**OFFICIAL COORDINATION REQUEST FOR
NON-ROUTINE OPERATIONS AND MAINTENANCE**

COORDINATION TITLE – 22 MCN 16 Early & Extended Ladder Outages for
Installation of Lamprey Passage Improvements
COORDINATION DATE – October 19, 2022
PROJECT - McNary Dam
RESPONSE DATE – November 2, 2022

Washington weir modifications.

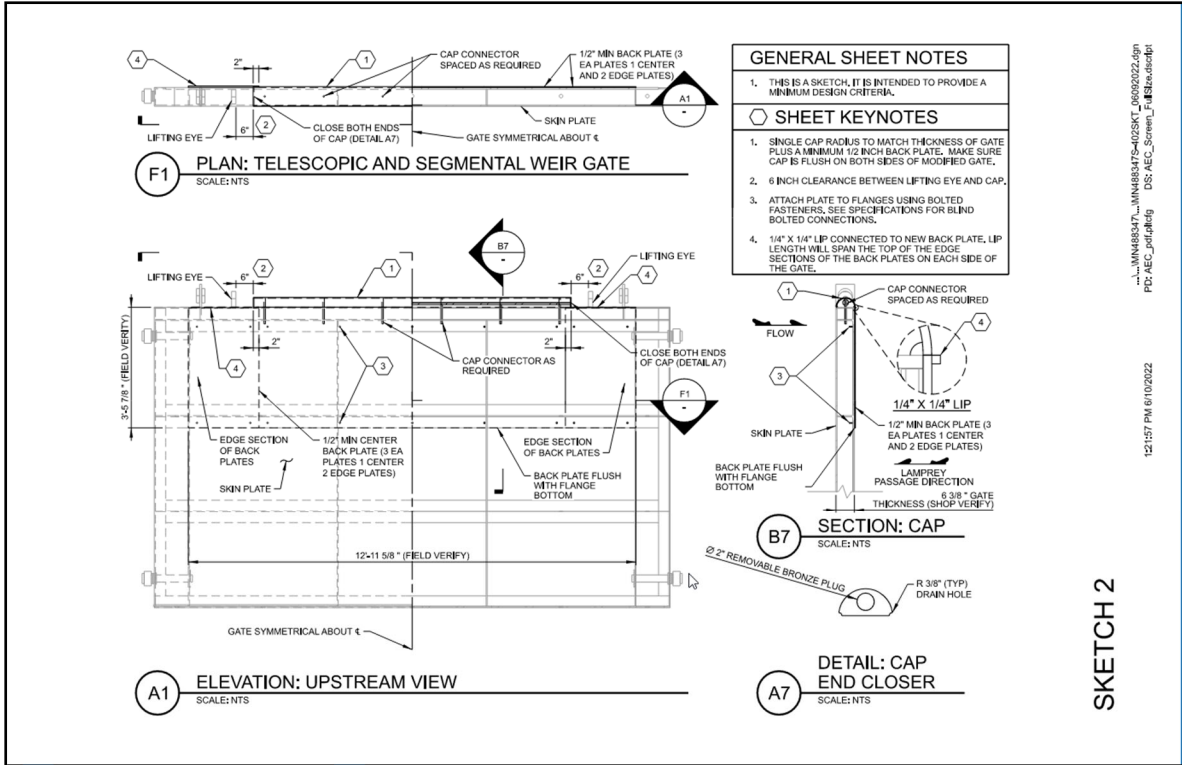
Thanks for the update and planning dates. Can you share who was awarded the contract and where the weir top sections are to be worked on (shop location)? Do you know why the modified parts require disassembly for transport? I assume the staggering of Washington shore and Oregon shore is to assure at least one ladder is operating. If the Washington shore work is delayed or goes overtime will the work on Oregon shore weir tops be delayed until the next winter work window? Is adult ladder dewatering still limited or has that issue been resolved? Any information you can share would be appreciated.

Thanks Scott,
Maybe my quick read misinterpreted the sections that will be transported and purpose of disassembly. I interpreted the tops section of each weir was being transported not the entire weir. Additionally, I assumed the shop would assemble the cap and plate to assure proper fit but remove it prior to transport back to McNary dam, which presumably will require USACE staff to reassemble it on site prior to reassembly of the telescoping sections. This would justify, at least in part, additional weeks need to complete the work to both weirs. Therefore, it seemed like a step that could potentially add time. As usual finding areas that reduce the OOS time could be an improvement that would be appreciated. I presume that the process could incorporate any early completion into refining the schedule if it comes to that (for example Washington shore returned to service earlier than expect, so move right to Oregon shore). I'll keep my eye out for the response on dewatering issues. Regards.

Disassembly of the telescoping weir gate is required for hauling/handling of multiple gates at one time. The gates will need to be manageable at the metal shop for adding of the rounded weir caps and skin plating and the surface finishing (sandblasting and painting).

Moving the weir to the shop is faster than trying to create a metal shop on the deck of the dam and construct large pieces of metal in the middle of winter. I do not know for sure why they will disassemble the weir to transport back to the dam. Those decision are up to the mechanics and engineers, but could be due to size or weight constraints which I could look into.
